**PLANNED UNIT DEVELOPMENT
& SUBDIVISION STAFF REPORT****Date: August 8, 2013****DEVELOPMENT NAME**

BDI Rangeline Subdivision

Planned Unit Development Approval to allow multiple buildings on a single building and Subdivision approval to create 1 lot.

SITE PLAN

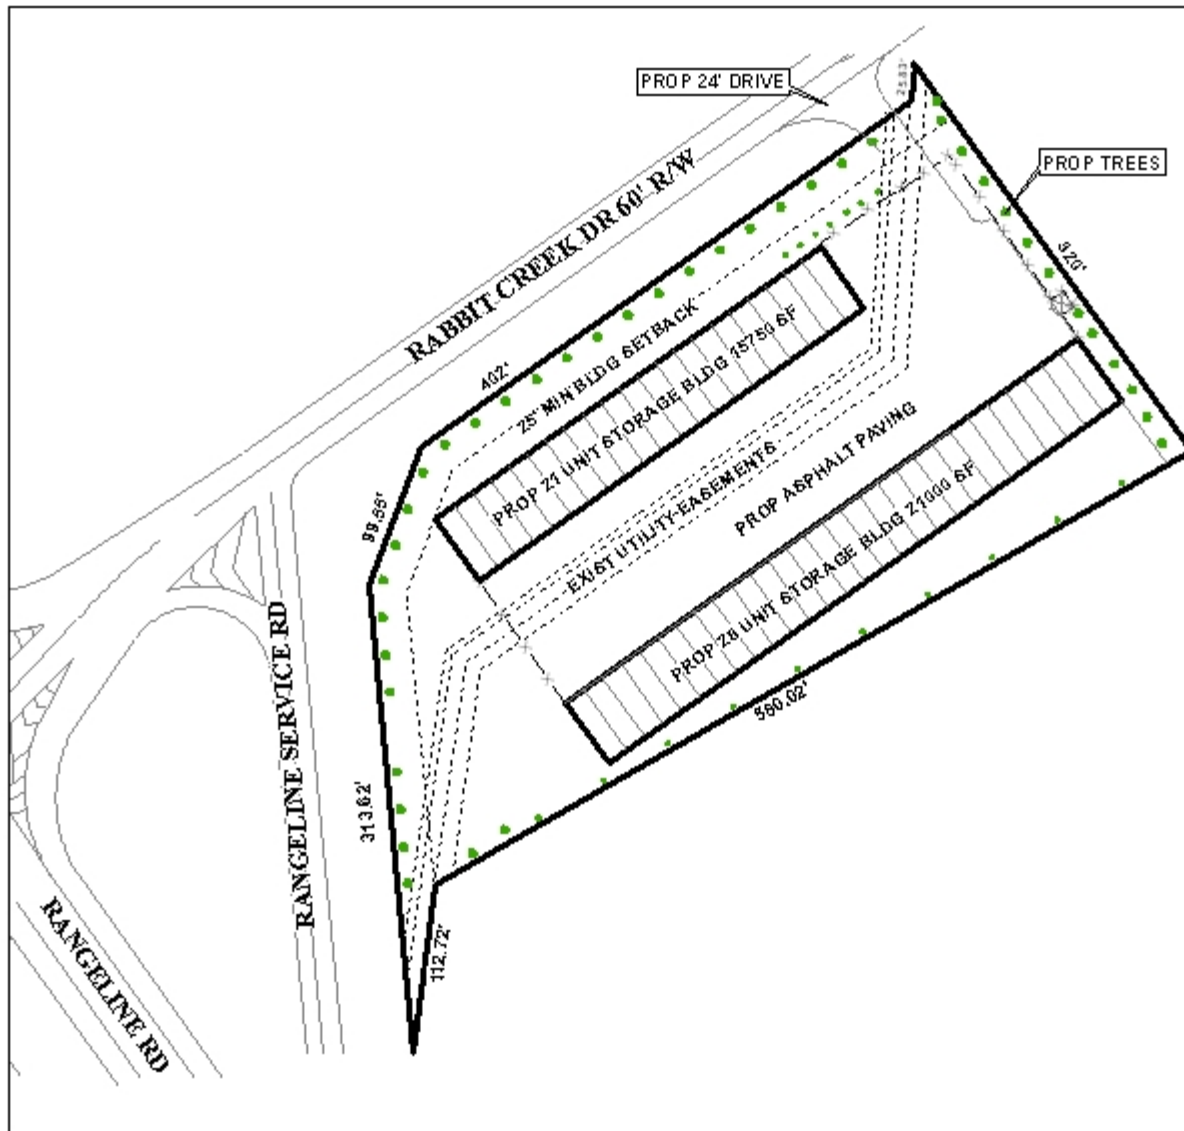
Regarding the proposed PUD the plan illustrates the proposed location of the boat and RV facility with possible units used for small businesses as well as the proposed landscaping. While the site has the required number of trees depicted it does not meet the required amount of frontage trees to comply with Tree and Landscaping requirements. Two additional frontage trees along Range Line Service Road are required.

The site appears to have utility easements that run from East to West throughout the proposed development and no construction of structures (i.e buildings) should be built within the easement.

A dumpster is depicted on the site plan. However, revisions should be made to clearly indicate the dumpster is enclosed on all three sides within a wooden or brick enclosure of at least 6 feet, but not to exceed 8 feet in height and that it will be connected to sanitary and sewer.

A sidewalk will be required for the proposed development, thus the site plan should be revised to depict a sidewalk along all street frontages, or an application for a sidewalk waiver should be submitted.

Revisions should be made to the PUD site plan and plat correcting the spelling of Rangeline Road to illustrate "Rangeline" as one word.

- 1) placement of two additional frontage trees located on the western portion of the property along Rangeline Service Road to comply with the tree and landscape requirements of the Zoning Ordinance;
- 2) placement of a note on site plan stating that no structures shall be built within the utility easement;
- 3) placement of a note on site plan to indicate the dumpster will be enclosed on all three sides and the type of enclosure materials;
- 4) placement of a note on site plan indicating that a new PUD application will be made to Planning Commission for the use of a storage unit for a business space;
- 5) placement of a note on site plan stating accessible parking will be provided as needed;

- 6) placement of a note on the site plan stating any units used for business purposes should be limited to business allowed in a B-5 district;
- 7) provision of a site plan at time of land disturbance depicting compliance with section 65-6.A. of the Zoning Ordinance regarding parking lot lighting and exterior lighting fixtures (not to exceed a 0.2 foot candle);
- 8) provision of a revised PUD site plan prior to the signing of the Final Plat;
- 9) full compliance with all other municipal codes and ordinances.
- 10) Revision of the site plan to depict a sidewalk, or submissions of an application for a sidewalk waiver.
